REVISED HONDA VALIDATION TEST REPORT

Revised Report – 1st Copy
November 06, 2000
Document Number ERL-0164
Thomas Sheridan

Product: P-SDI Inflator

To: Bill Martin / Kevin Fitzgerald
From: Tom Sheridan
Subject: Corrected Honda Test data

HONDA PSDI Group 1 (Baseline)
@ +22 deg.C (Amb) Simultaneously

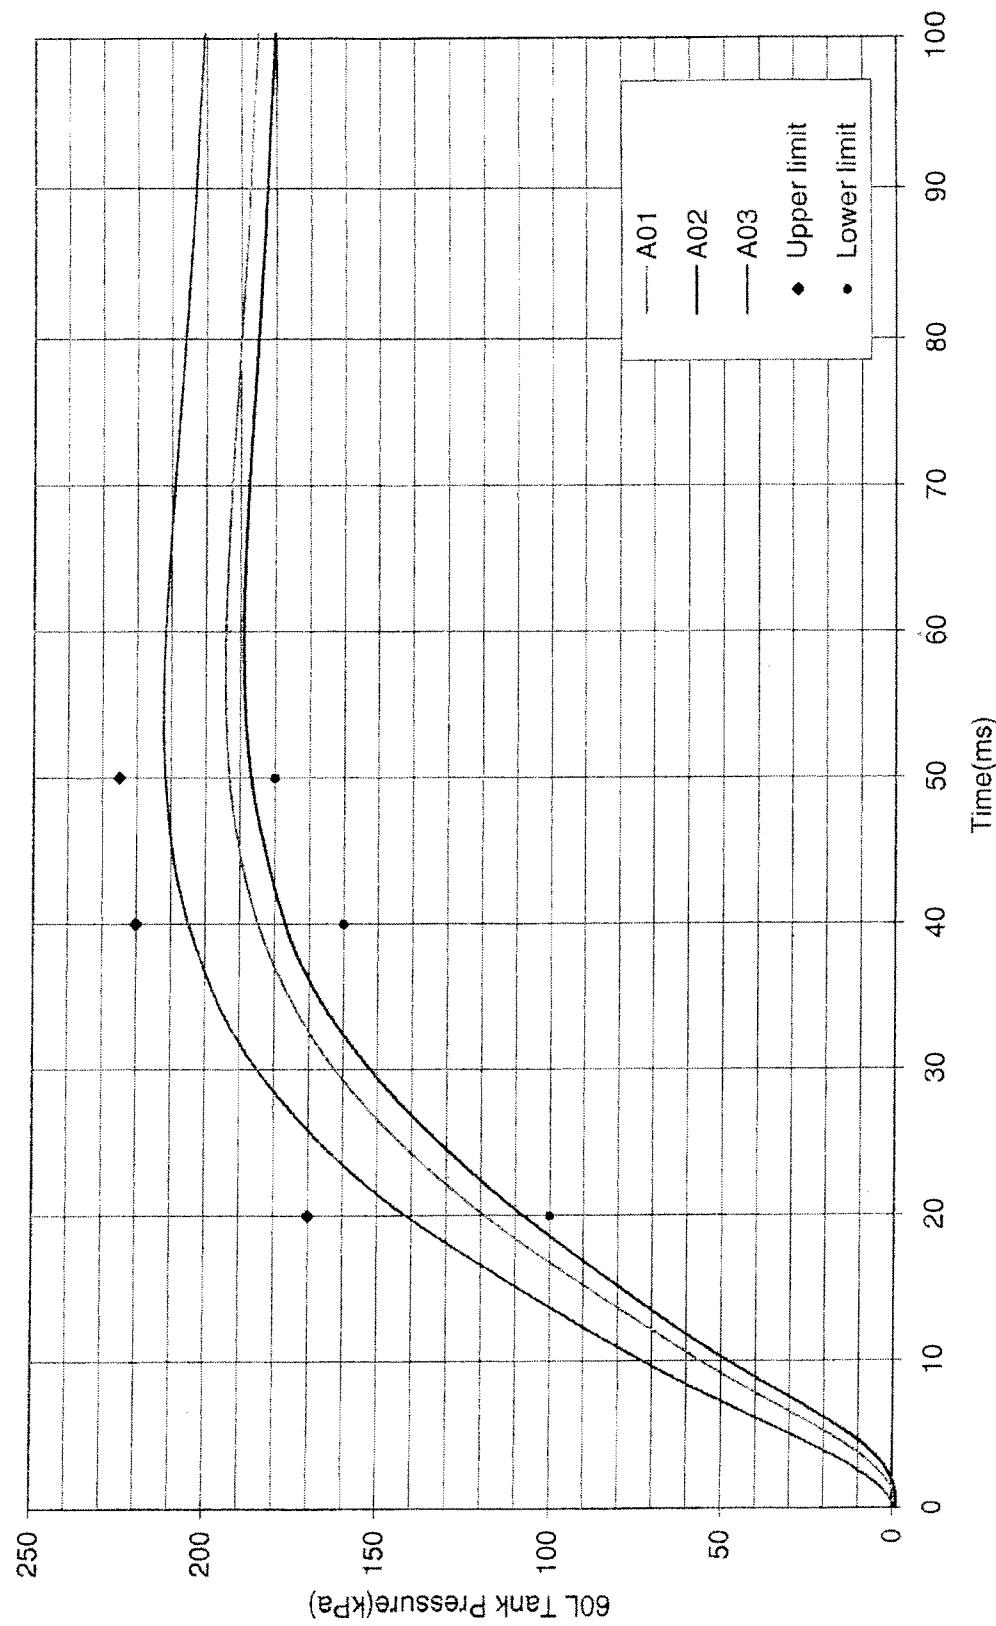
Incorrect data.
Data does not match EAR. 8A249A04-
8A249A010 does not exist. Test EAR
cannot be found. 8A249A01-8A249A03
corrected data on following page.

Corrected chart and data for
8A249 Group A.

HONDA PSDI Group1 (Baseline)
@ +85 deg.C (Hot) Simultaneously

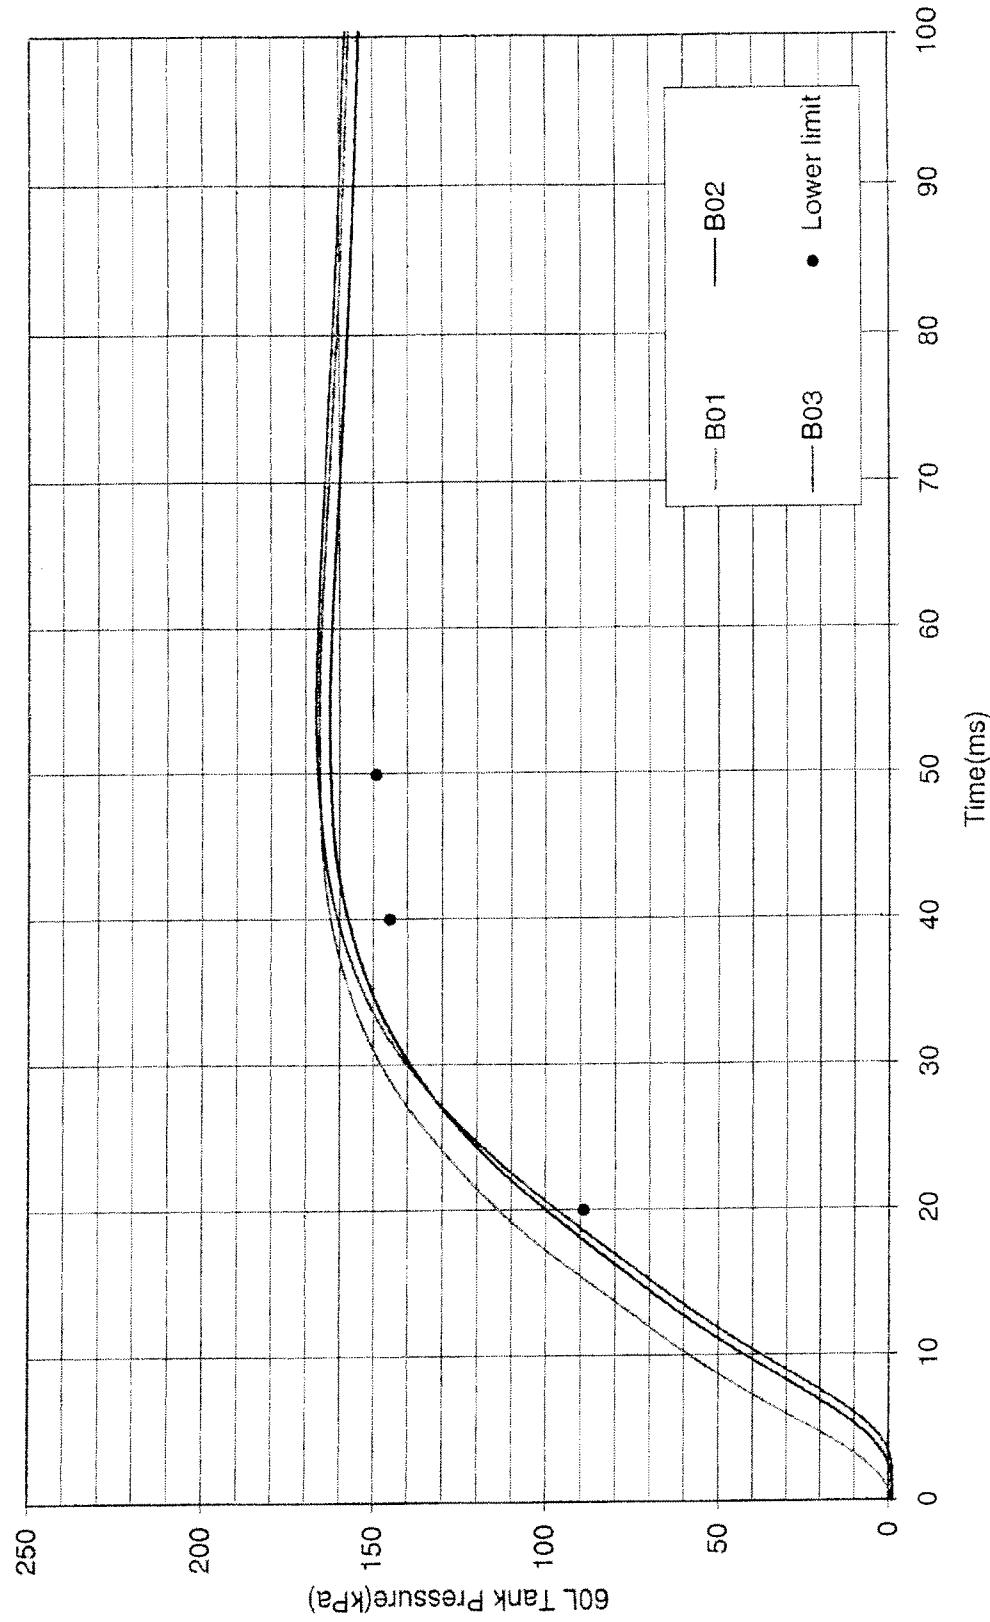
Data does not match EAR.
8A249B01-8A249AB03 corrected
data on following page.

Corrected chart and data for
8A249 Group B.

HONDA PSDI Group 4 (High Temperature Aging Test)
@ -35 deg C (Cold) Simultaneously

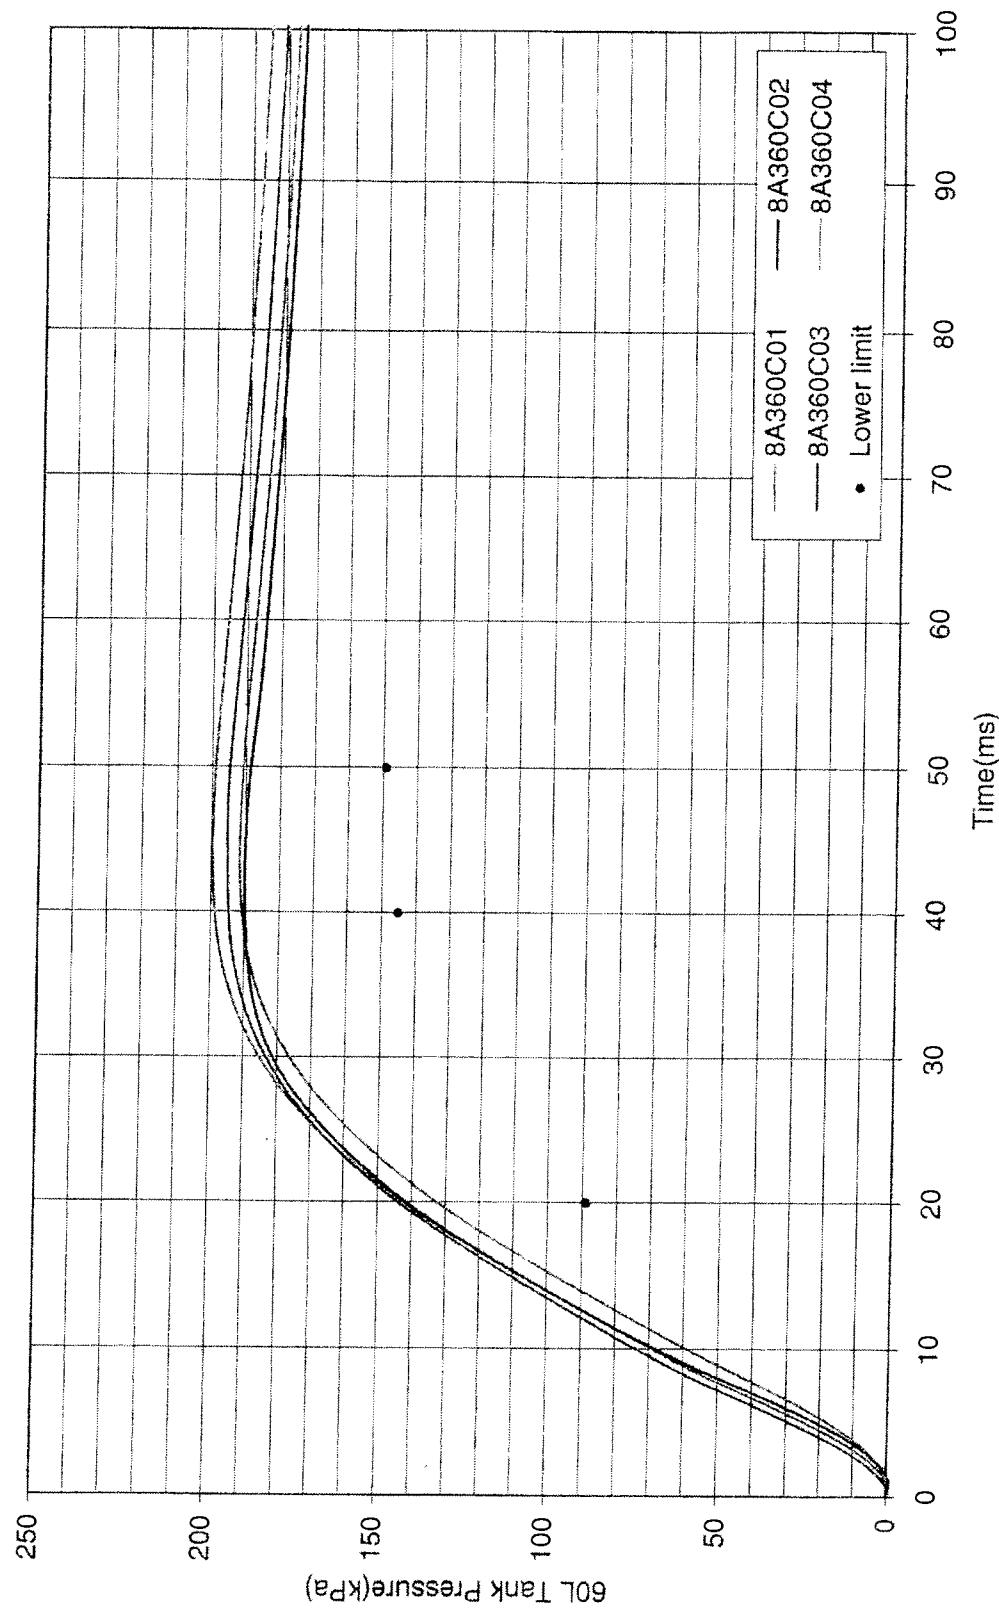
Incorrect data.
Data does not match EAR.
8A360C01-8A360C04 corrected
data on following page.

Corrected chart and data for
8A360 Group C.

HONDA PSDI Group 4 (High Temperature Aging Test)
@ +85 deg.C (Hot) Simultaneously

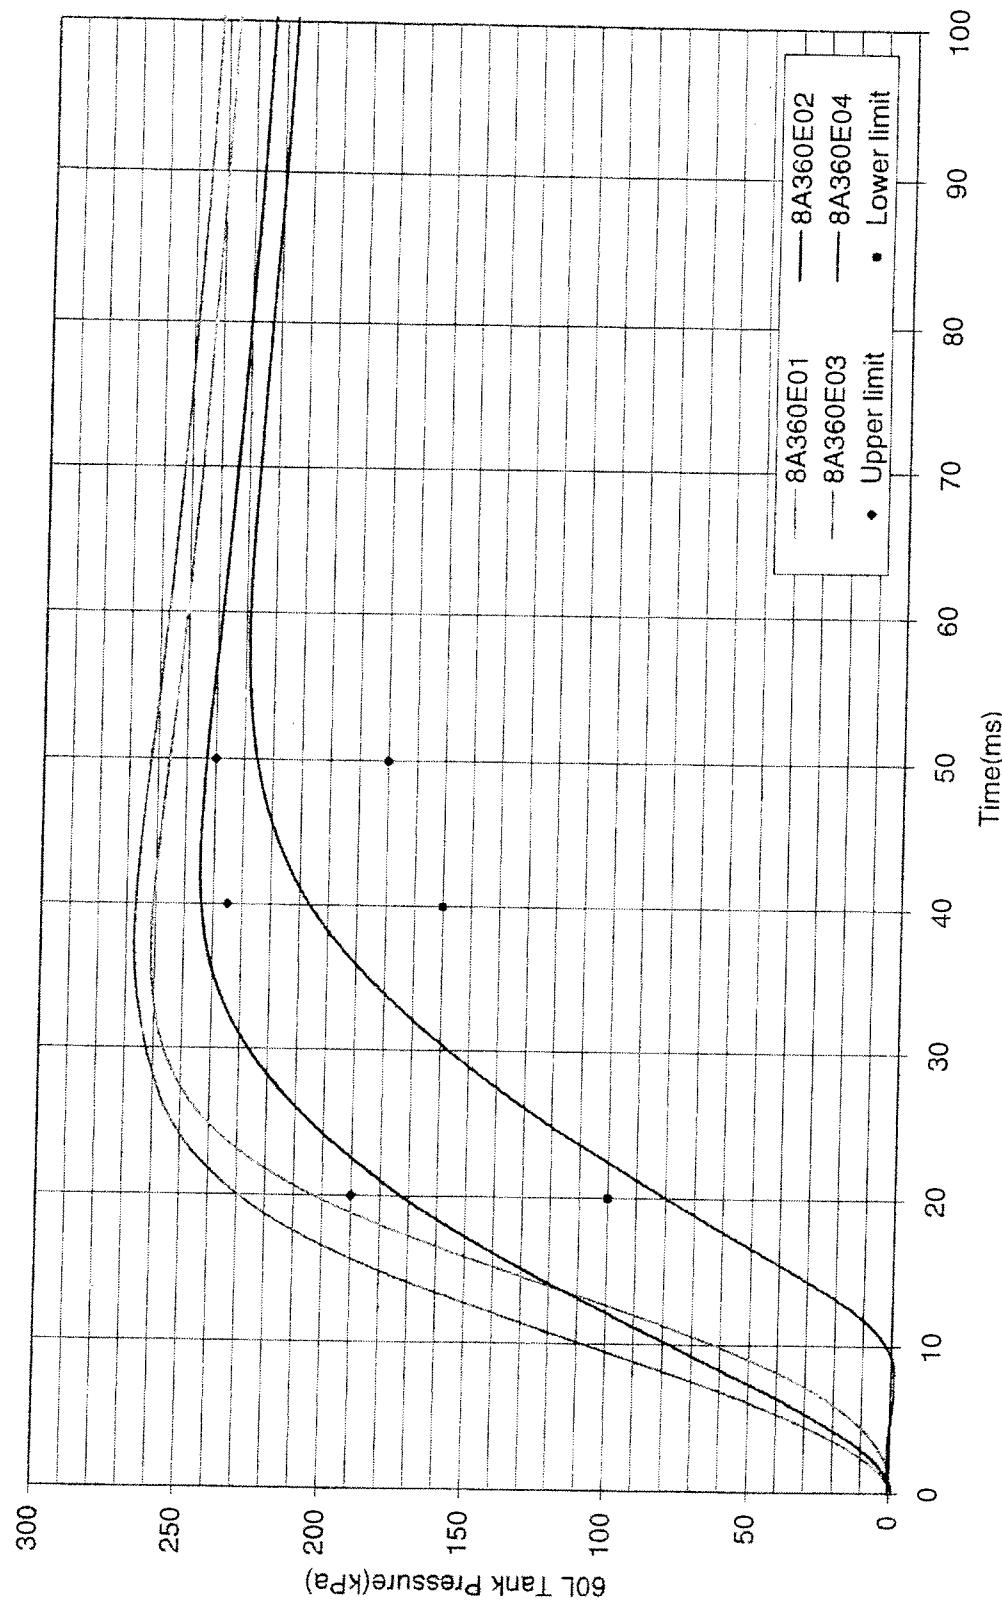
Incorrect data.
Data does not match EAR.
8A360E01-8A360E04 corrected
data on following page.

Corrected chart and data for
8A360 Group E.

HONDA PSDI Group 5 (Low Temperature Aging Test)
@ +22 deg.C (Amb) Simultaneously

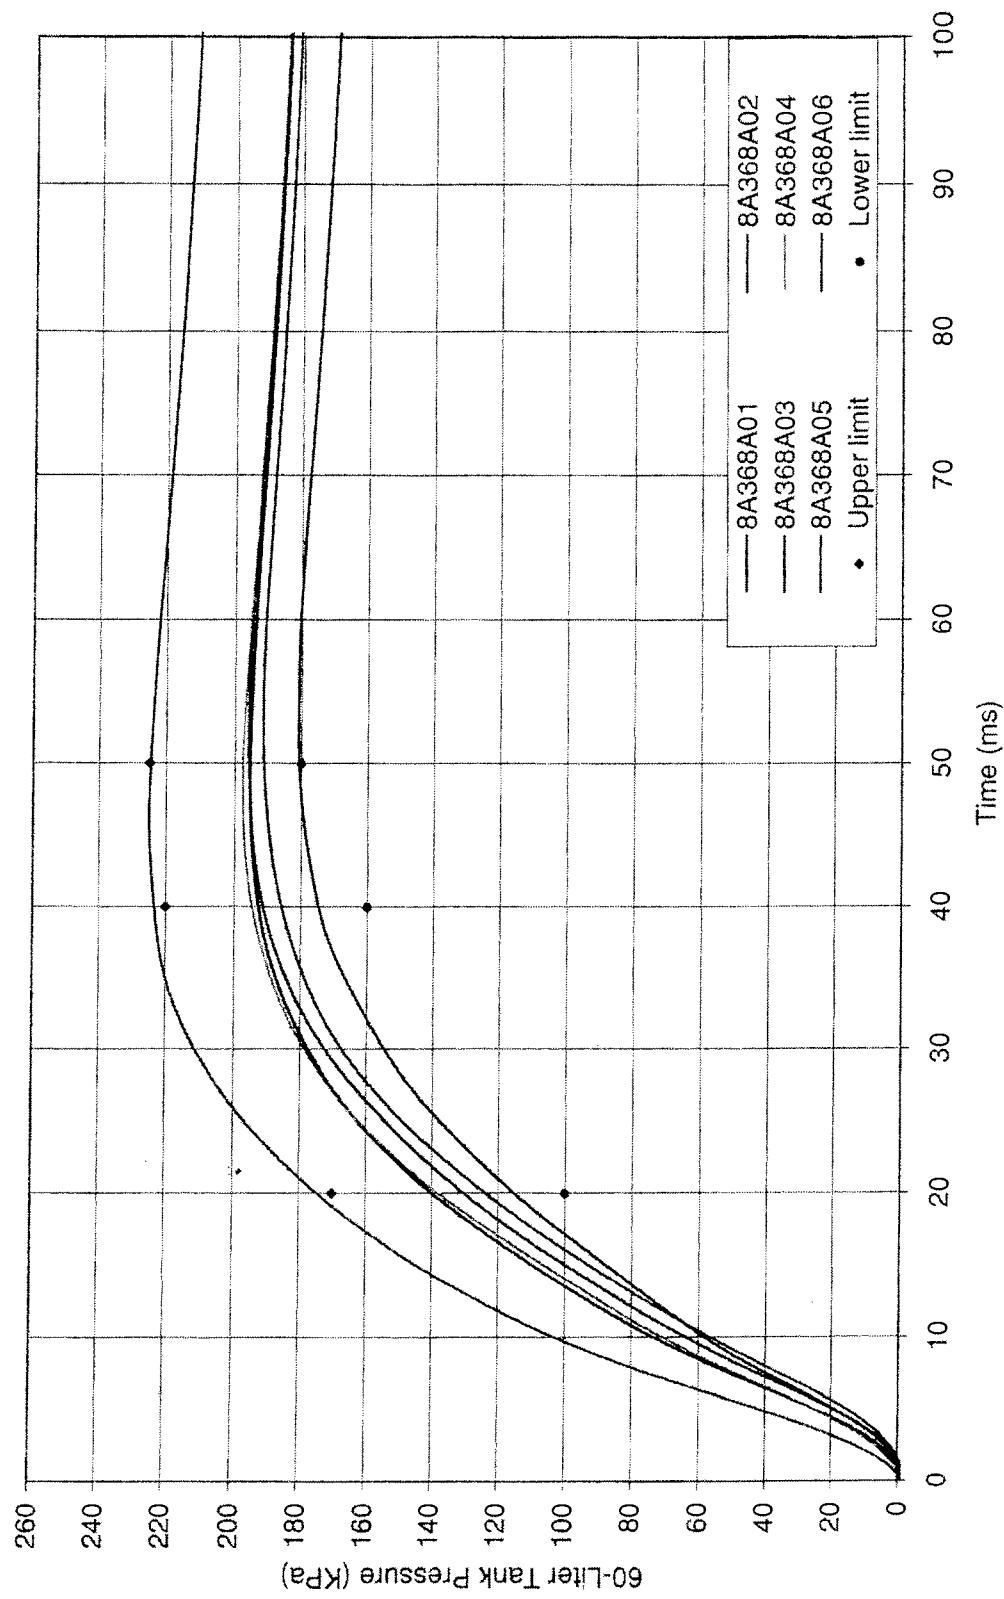
8A368A01-8A368A06 corrected
data on following page.

Corrected chart and data for
8A368 Group A.

HONDA PSDI Group 7 (Vibration & Thermal Cycle)
@+22 deg.C (Amb) 20ms delay

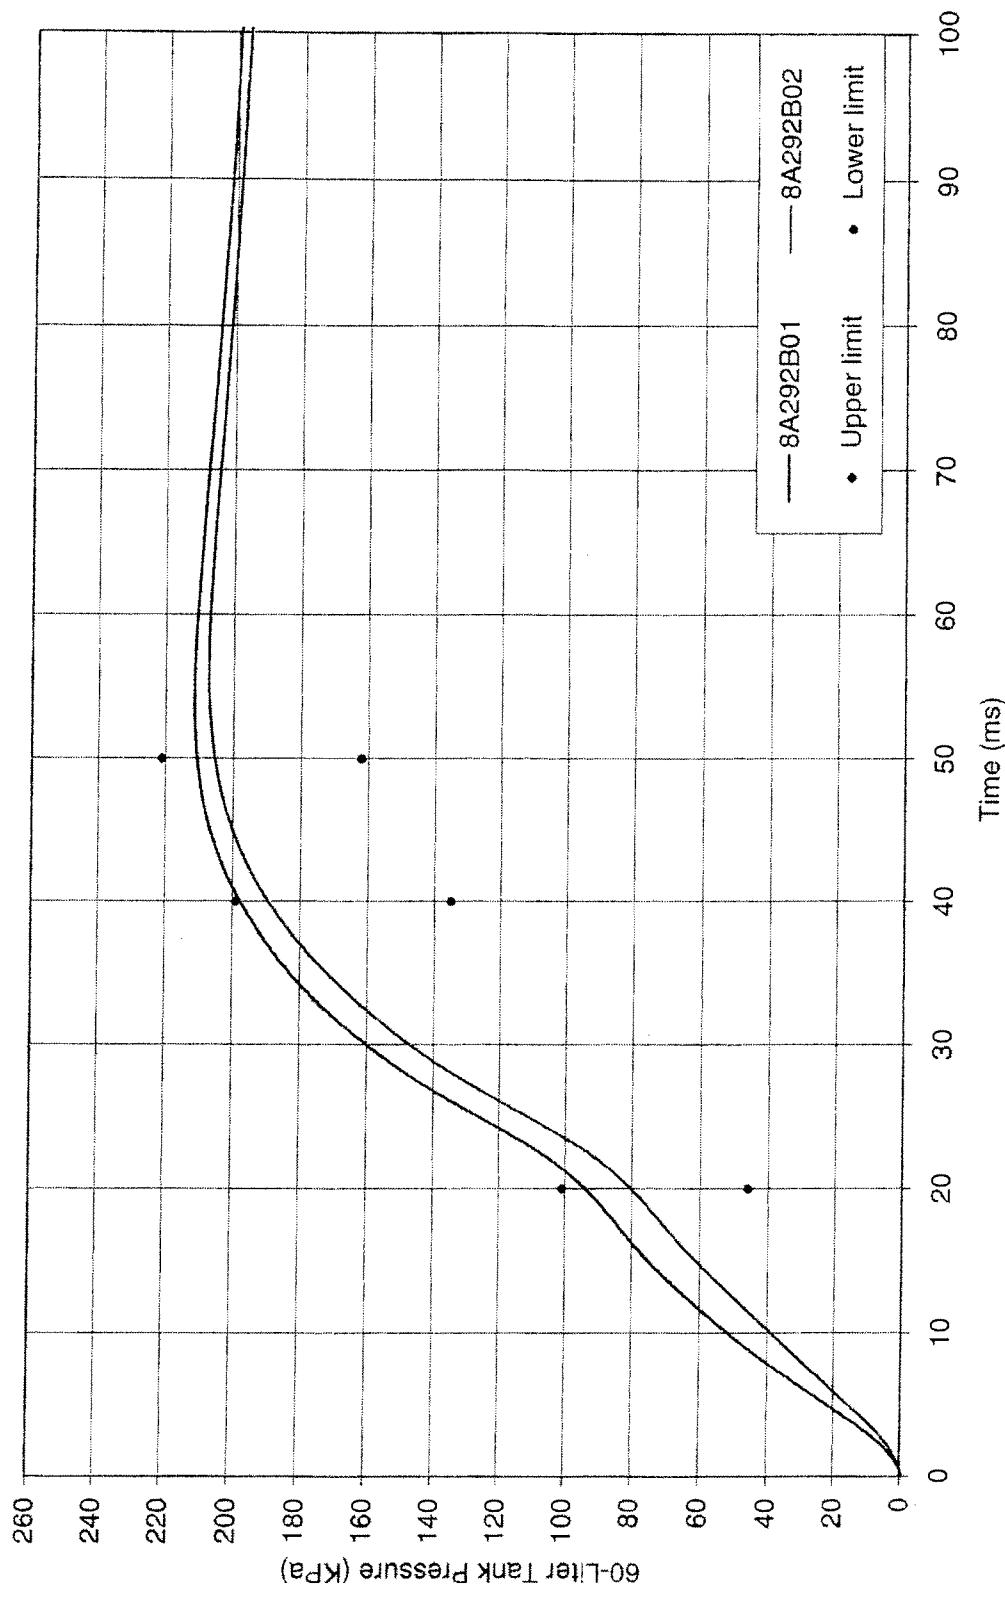
Incorrect data.
Data does not match EAR.
8A292B01 and 8A292B02
corrected data on following page.

Corrected chart and data for
8A292 Group B.

HONDA PSDI Group 7 (Vibration & Thermal Cycle)
@ +85 deg.C (Hot) Simultaneously

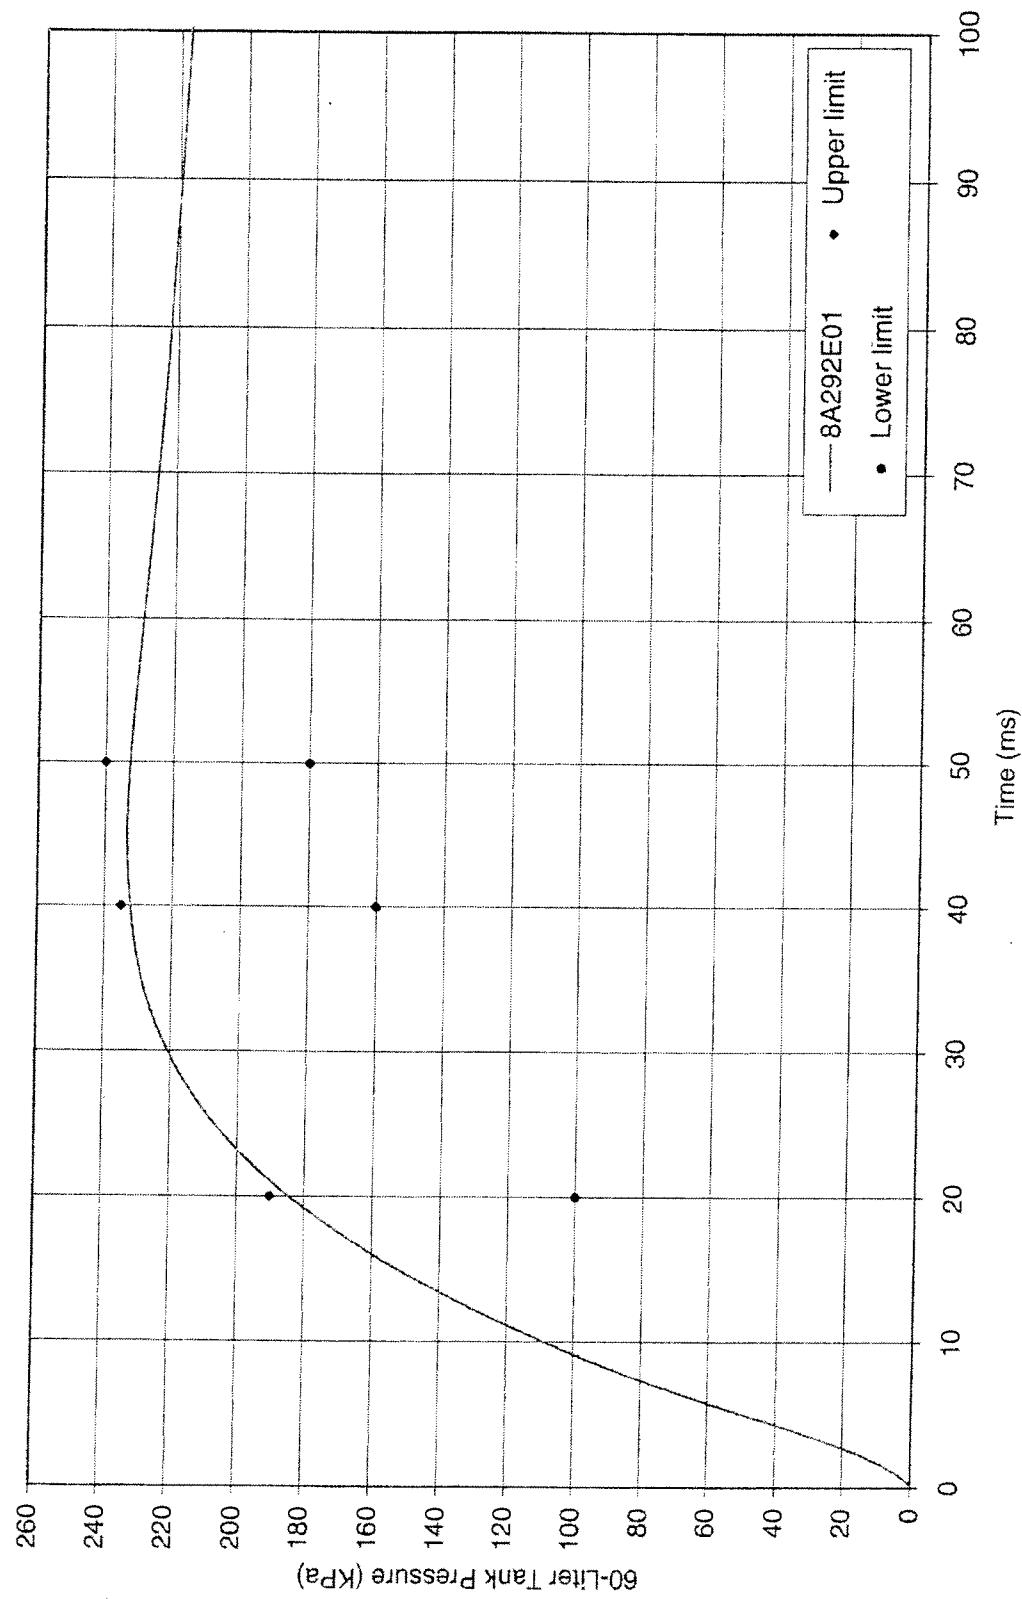
Incorrect data.
Data does not match EAR.
8A292E02 and 8A292E03 do not
exist. 8A292E01 corrected data
on following page.

Corrected chart and data for
8A292 Group E.
